Re: S.A. Dunn Construction and Demolition Landfill and Mine
DEC No.4-3899-00006

CITY OF RENSSELAER
SUPPLEMENTAL COMMENTS ON S.A. DUNN
CONSTRUCTION AND DEMOLITION DEBRIS
LANDFILL AND MINE

**DUNN C&D LANDFILL
IMPACTS ASSESSMENT**

November 10, 2022

PHOTO 1

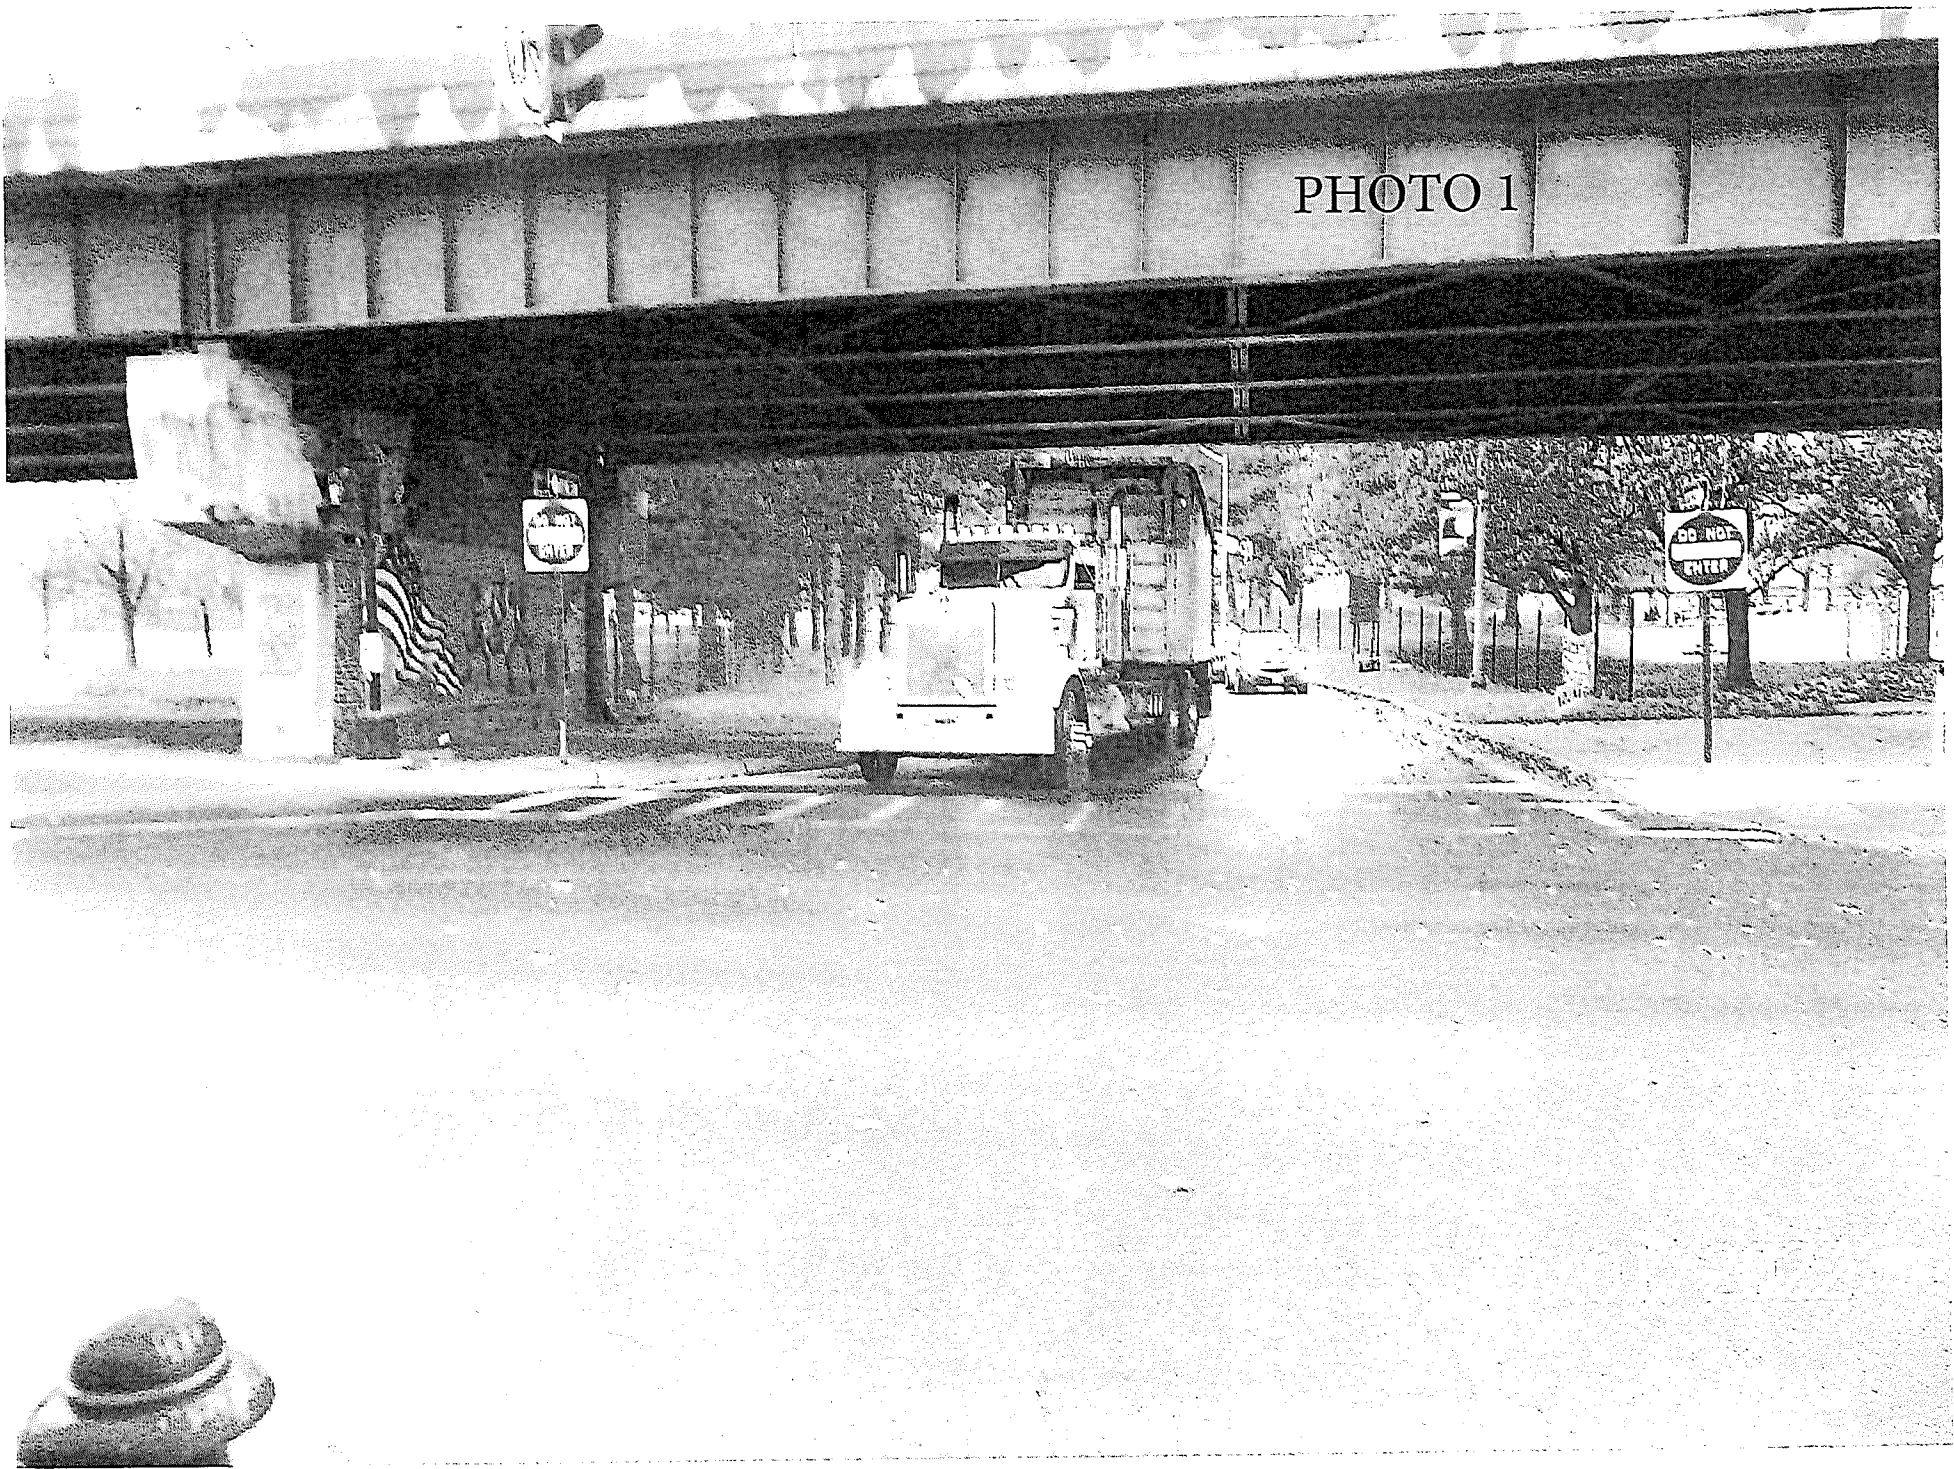
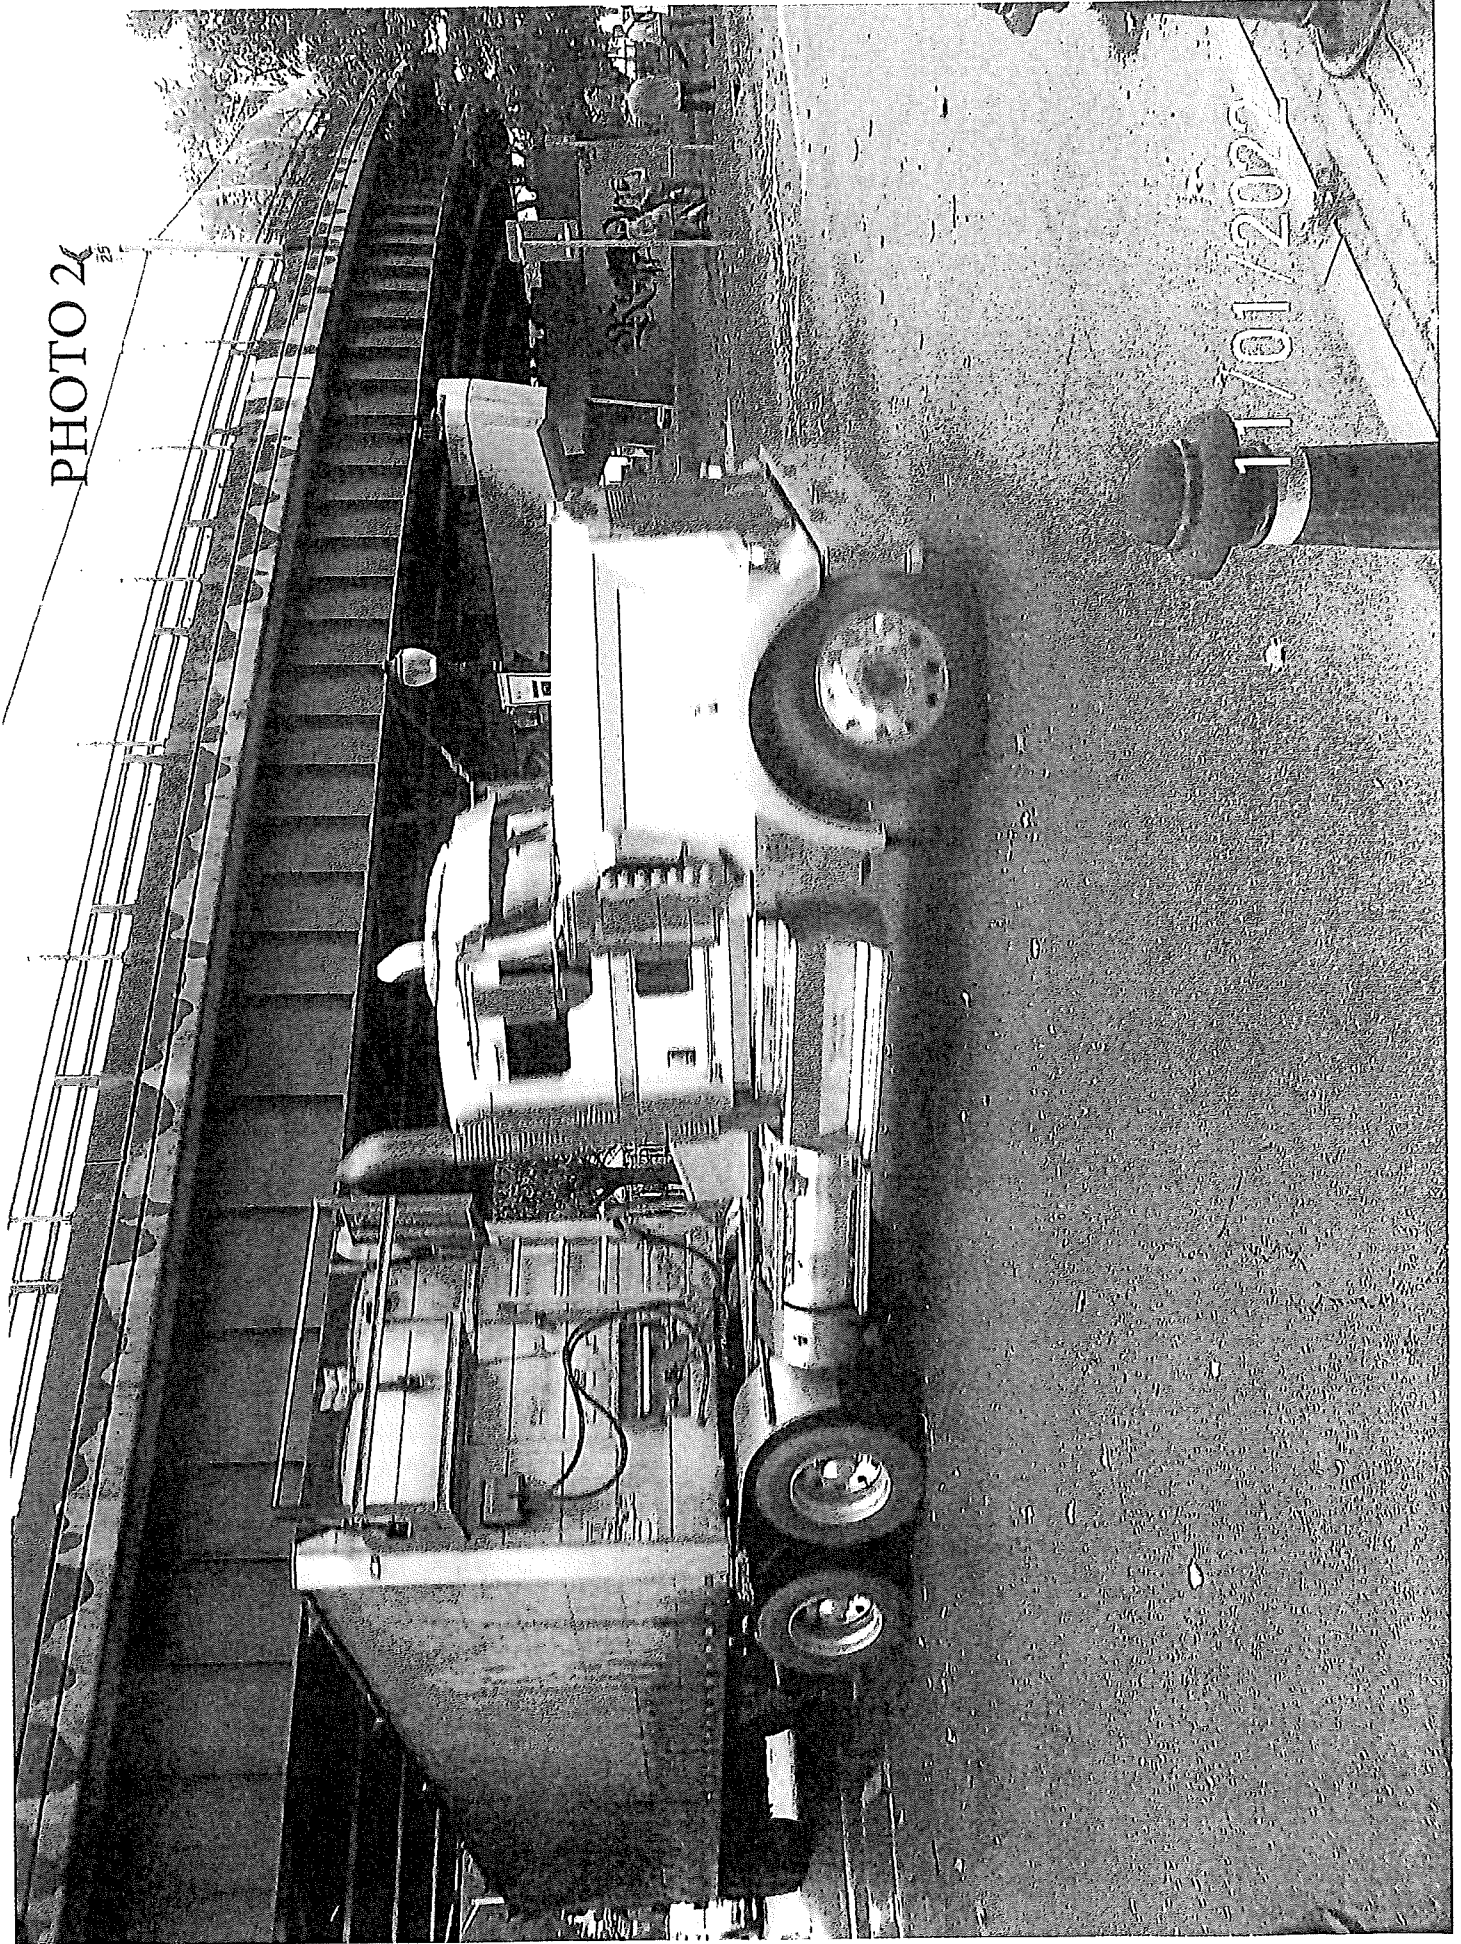
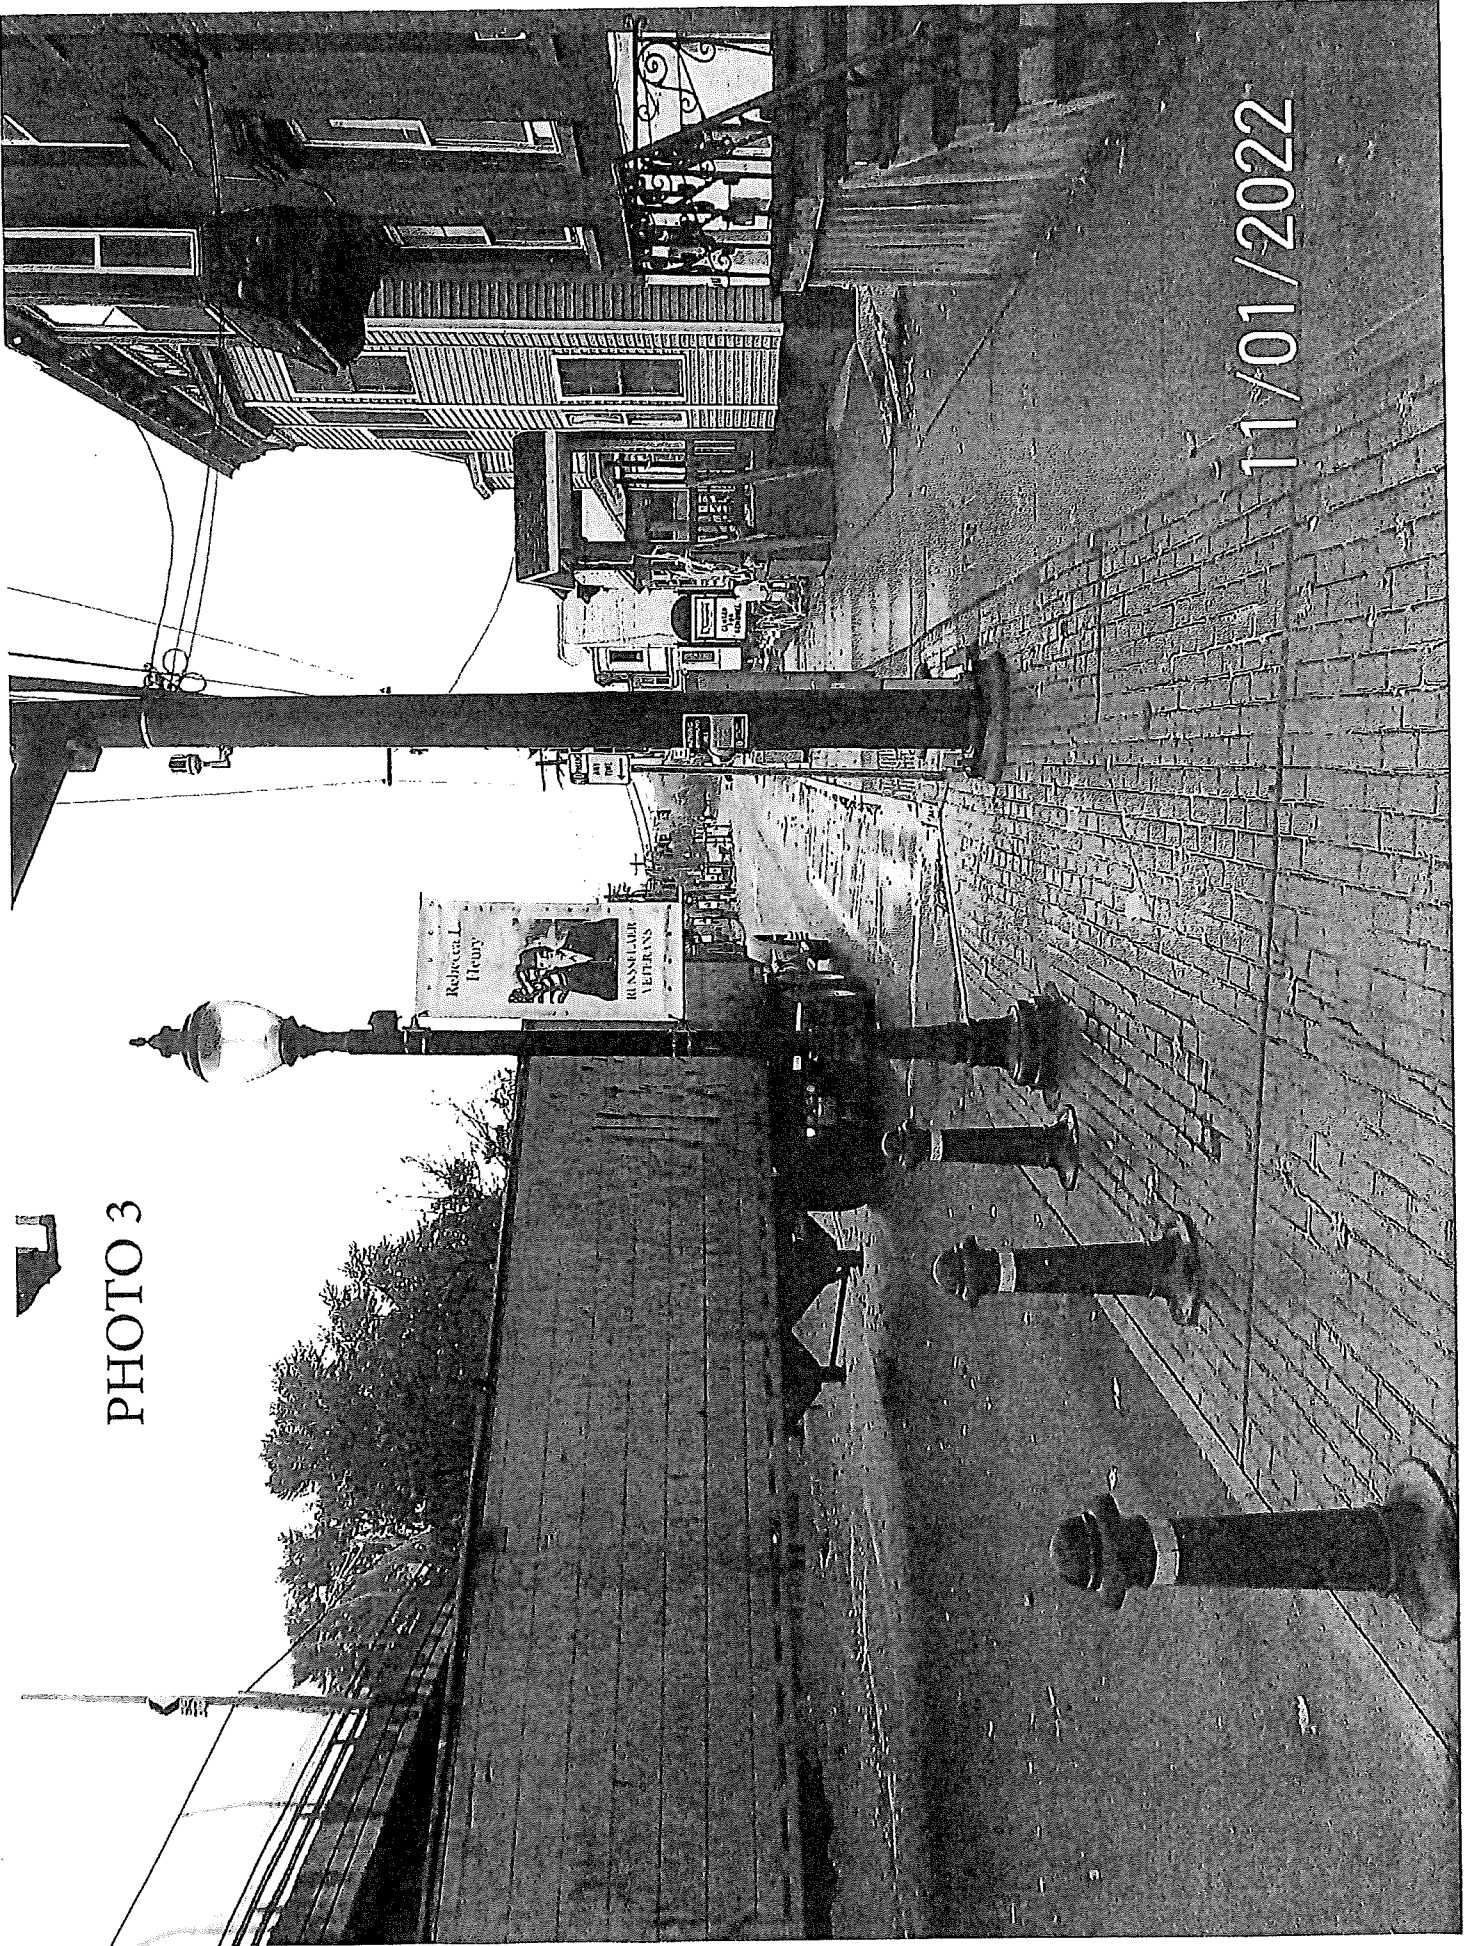
Of the four intersections observed this one operates the worse and presents the most safety concerns. Most of the tractor trailers observed exit down the ramp and move directly into the right turn lane, either partially or completely, to make the left turn (see photos 1-4). On some occasions it was observed that other traffic coming down the ramp and making left turns continues along beside the truck making a left turn which makes for a dangerous situation when both try to turn left at the same time. If the truck does stay in the left turn lane they need to move dramatically into the right turn lane when they start the turn (see photos 5-8). This endangers traffic legally in the right turn lane. It does not appear that any left turn movement can be made if they stay completely within the left turn lane. If they try they ride up onto the
